FORM APPROVED  
OMB NO. 1004-0137  
Expires: January 31, 2018**SUNDRY NOTICES AND REPORTS ON WELLS**  
**Do not use this form for proposals to drill or to re-enter an abandoned well. Use form 3160-3 (APD) for such proposals.**5. Lease Serial No.  
NMNM91078

☒ Oil Well ☐ Gas Well ☐ Other8. Well Name and No.  
LONGVIEW 1 23

RKI EXPLORATION & PRODUCTION, LLC RESPECTFULLY REQUESTS TO P&A THE ABOVE MENTIONED WELL.  
THE WBD AND PROCESS ARE ATTACHED.

Longview "1" #23  
Proposed WB

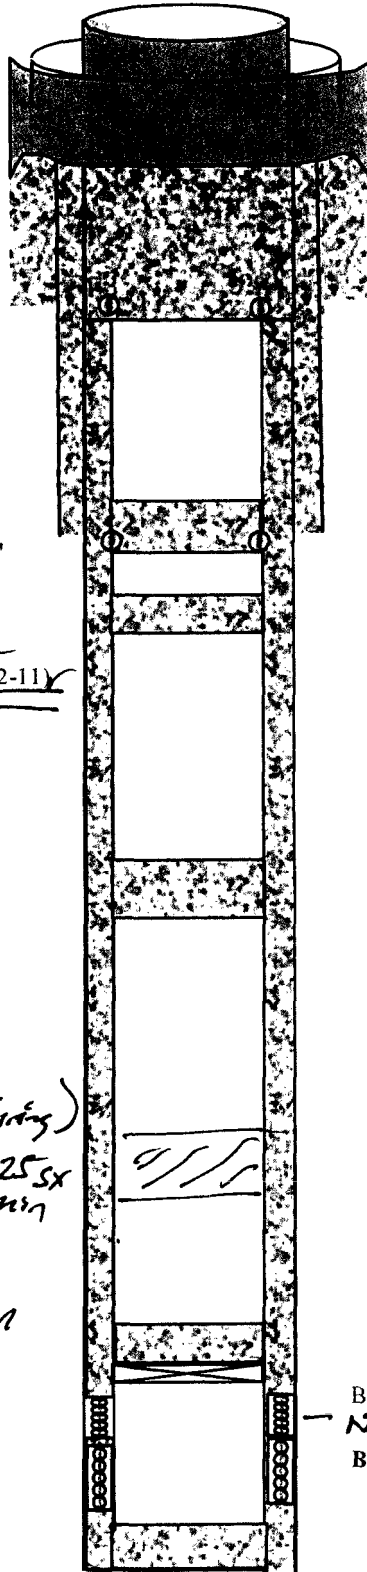
*Perf @ 60' 892 to  
Surf.*

*Perf @ 343' & Sqz. 140 sxs. to surface*

*Spot 25*

*Spot OK*

*Perf @ 2,820' & Sqz. 70 sxs. & Tag @ 2,670'*

*Add Plug (Top Bone Spring)  
From 6382 - 6222. 25 sxs  
min*

*8353*

*25 sxs min*

Set CIBP @ ~~7,329'~~ & Spot ~~30~~ sxs. on top

*T/salt 375 +/-*

*B/salt 2580 +/-*

*No Perfs Recorded*
